Timeline and Explanation of Changes in GRBP/2024/22

Task from January
GRBP Subgroup on UN-R51 & UN-R 138

8-10 April 2025, Berlin

Evolution of Supplement 11

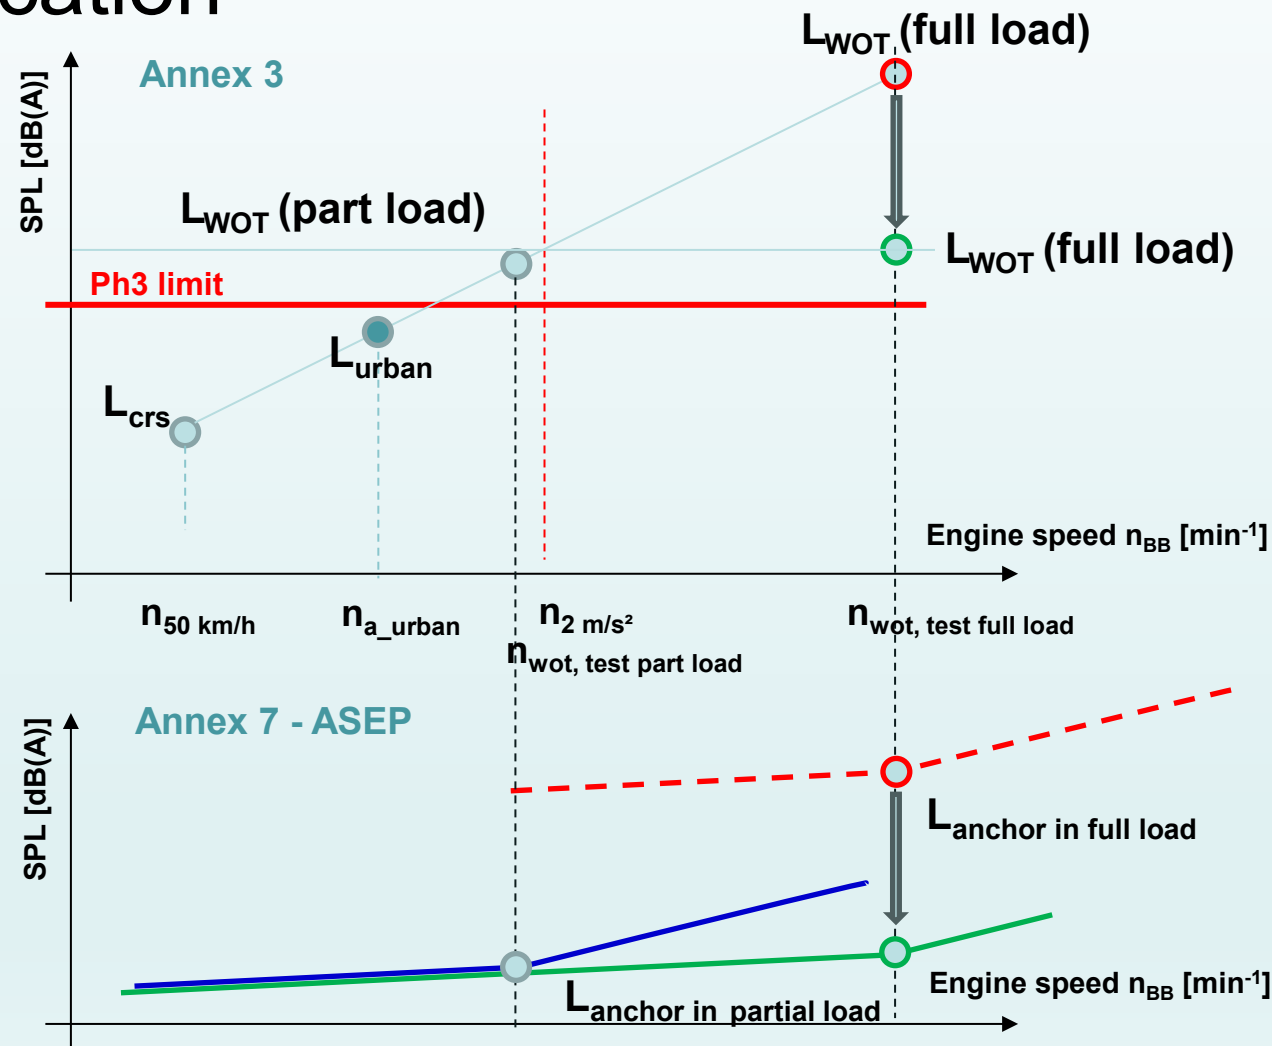
Vehicles with propulsion technologies other than combustion engines, not exempted by item (d) of paragraph 6.2.3. of the main body, shall comply with Analysis method 1 only. The Analysis method 2 and the Reference sound assessment are not applicable for these vehicles.

Vehicles with propulsion technologies other than combustion engines not exempted by item (d) of paragraph 6.2.3. of the main body shall comply with Analysis method 1 **(Slope assessment method)** only.

This shall apply as well to hybrid electric vehicles tested without an operating combustion engine.

Manufacturers of vehicles according to this paragraph shall provide a statement of compliance for ASEP, confirming that the vehicle **complies with the specifications described in paragraph 3.5. of this Annex, when tested with any acceleration within the control range in paragraph 2.3.**

Vehicles with propulsion technologies other than combustion engines ~~not exempted by item (d) of paragraph 6.2.3. of the main body~~ shall comply with Analysis method 1 (Slope assessment method) only.

- Limit EVs to slope assessment, since the other methods are not suitable.
- No exemption for Hybrids.

- L_{urban} method gives too big benefits for high acceleration.
- Reference Sound Assessment is meaningless, as there is too little reference data of EVs tested under R51.02

- Without an operating ICE, hybrids are comparable to pure electric vehicles.
- Only serial hybrids have been temporarily exempted by the transitional provisions (see slide 9 – missing method).

8. Virtual Engine Speed (Anchor Point)
Annex 7 of UN-R 51: Paragraph 3.1./2.5.2.

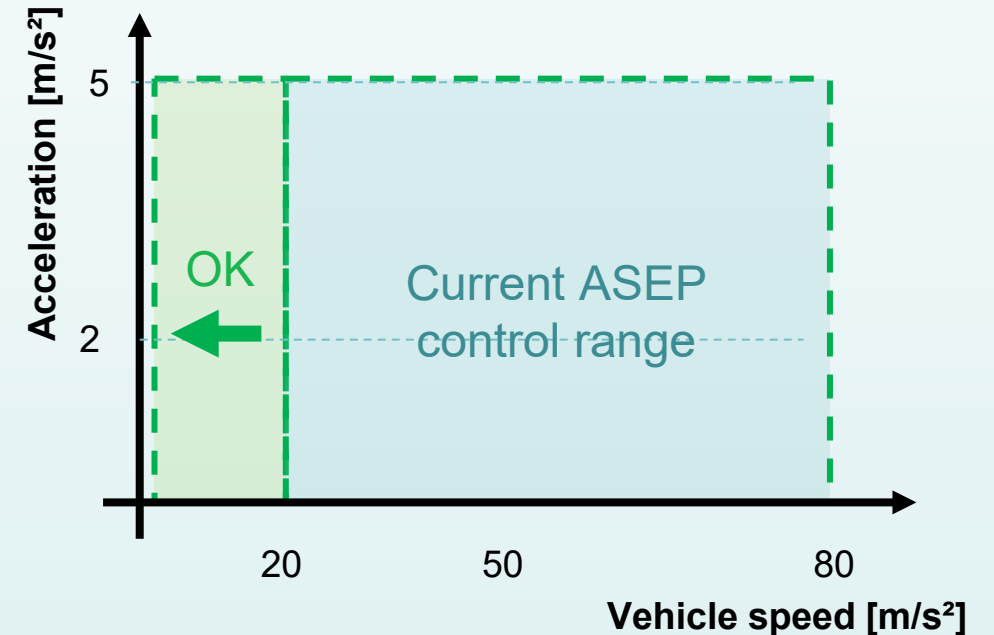
The engine speeds for the calculation of the slope in the paragraphs 3.2. and 3.3. is calculated from the vehicle speeds $v_{BB,\kappa j}$ by the formula

$$n_{BB,\kappa j} = 1000 * v_{BB,\kappa j}/[xx]$$

For vehicles according to paragraph 1.1. of this Annex the engine speed per test run shall be calculated by the formula below

$$n_{BB,\kappa j} = v_{BB,\kappa j}/\left(20 - 8 \times log_{10}\left(\frac{a_{test}}{a_{anchor}}\right)\right) \times 1000$$

for achieved accelerations $a_{test} > a_{anchor}$; and

$$n_{BB,\kappa j} = v_{BB,\kappa j}/20 \times 1000$$

for achieved accelerations $a_{test} \leq a_{anchor}$ with $a_{anchor} = a_{wot,test}$ of Annex 3 (average of 4 runs)

- The rotational speed of electric motors is not relevant for ASEP, which is based on ICE engine speed. A conversion of vehicle speed to engine rotational speed was necessary.
- Most tyres have a higher sound under acceleration (high torque applied to the tyre), and risk to penalize vehicles without an ESES.

- The basic gear ratio of 20 km/h/1000rpm was chosen based on the average speed evolution of tyre sound without torque.
- An increase of torque is typically combined with a downshift to lower gears (ICE behavior).
- For EVs and only for accelerations higher than aanchor, the virtual gear ratio has slightly been modified. This moves nbb to higher rpm causing higher limits during high acceleration (> 2 m/s², typically non-urban accelerations). The graph shows the possible increase of sound during high accelerations (for a short time only).
- This improves safety with a higher level of sound during high accelerations (> 2 m/s², typically non-urban accelerations).
